# SERVICE BULLETIN

SERVICE BULLETIN NO: 28-004

## FUEL - DISTRIBUTION ENGINE DRIVEN PUMP - TORQUE CHECK OF RELIEF-VALVE-BODY SCREWS

Torque Check and Fuel Leak Inspection of the EDP  
Figure 1

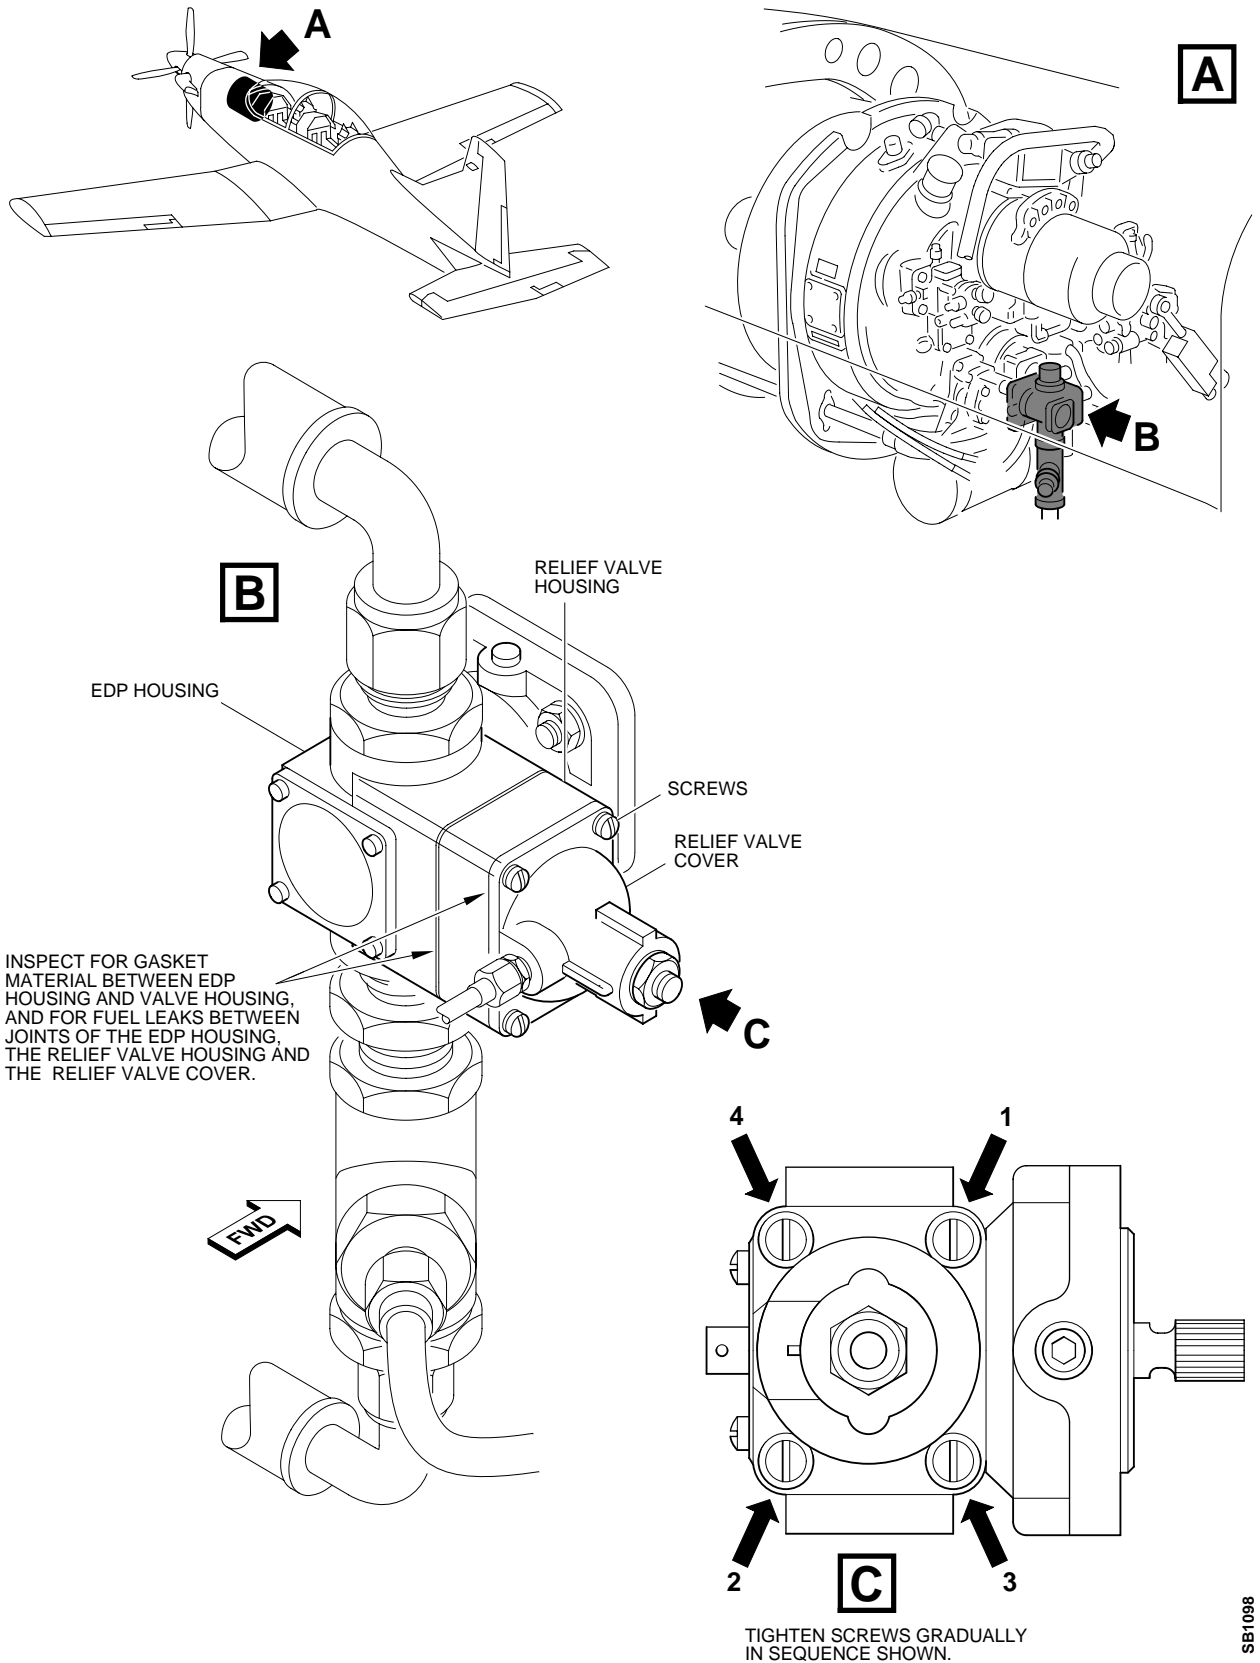
- (1) Visually inspect the joints between the EDP housing, relief valve housing and the relief valve cover for:

- Fuel leakage
- Gasket material pushed out

- (2) If the EDP shows signs of fuel leakage or the gasket between the EDP housing and the relief valve housing has been pushed out, replace the EDP (Ref. AMM, 28-20-10, Page Block 401).

- (3) Use a torque screwdriver to do a check of the torque value of the relief-valve-cover screws. Do the check clockwise only. The minimum torque must be 23 lbf in. (2,6 Nm).

- (4) If the torque found at Step (3) is more than 23 lbf in. (2,6 Nm), it is not necessary to loosen the screws and torque them again.

- (5) If the relief-valve-cover screws are loose, or the torque found at Step (3) is less than 23 lbf in. (2,6 Nm), do as follows:

- (a) Cut, remove and discard the lockwire that safeties the relief-valve-cover screws.

- (b) Torque the screws gradually to between 23 and 25 lbf in. (2,6 and 2,83 Nm). Do this in the sequence shown in Figure 1, Detail B.

- (c) Safety the screws with lockwire (Material Item P02-001).
